Enquiries: Chris Bryant  
Direct: 07 5433 2484  
Our Ref: DA/2024/4695  
Your Ref: LR2440  
Date: 18 November 2024

**Re: INFORMATION REQUEST**  
***Under Section 12 of the Development Assessment Rules***  
**Development Application No.: DA/2024/4695**  
**Property Location: 25 Marine Parade, Redcliffe**  
**Property Description: Lot 427 SL 1339**  
**Development Type: Material Change of Use - Development Permit for Multiple Dwelling (5 Dwellings)**

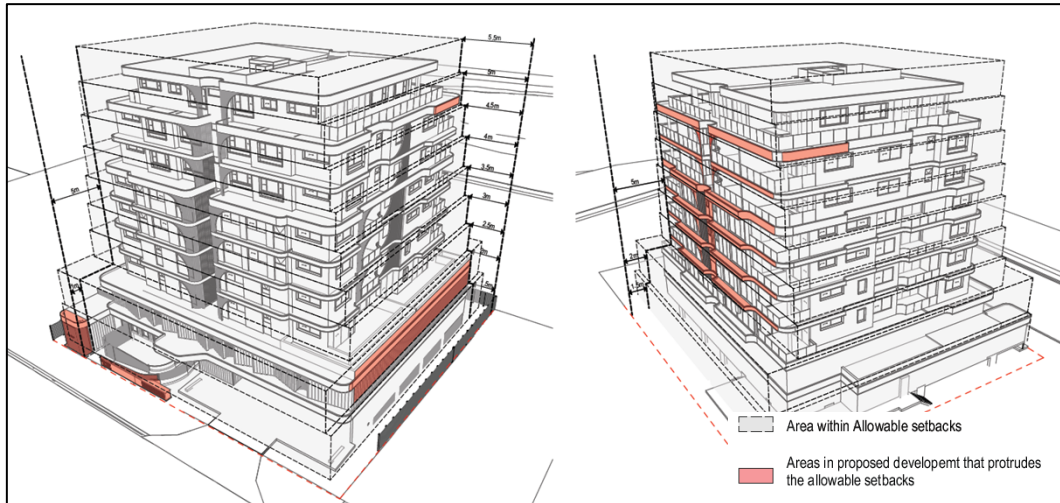
3. Please submit a perspective view of the development from each corner with the planning scheme nominated side and rear setbacks (as detailed within Table 6.2.6.4.3 'Setbacks' - Setback (Residential uses)) intersecting through the development as shown below from a different proposal as an example.

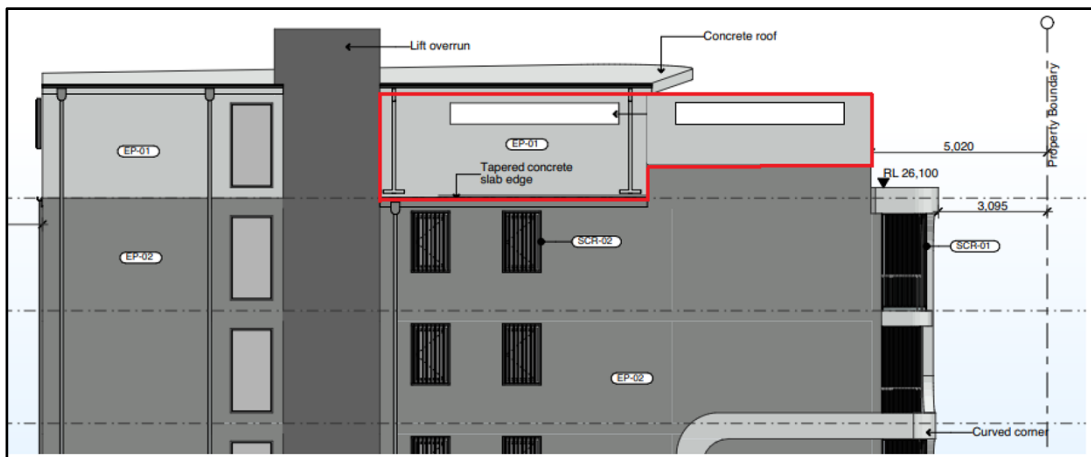
Further, due to its proximity to adjoining rooms and balconies, consideration is to be given to providing further screening to the side (southern) boundary. One solution might be to extend the wall as indicated below however provision of the digital 3D model as requested above will assist in identifying and considering the best possible option. Please demonstrate that the rooftop terrace will not have noise, light, visual impacts on adjoining properties.
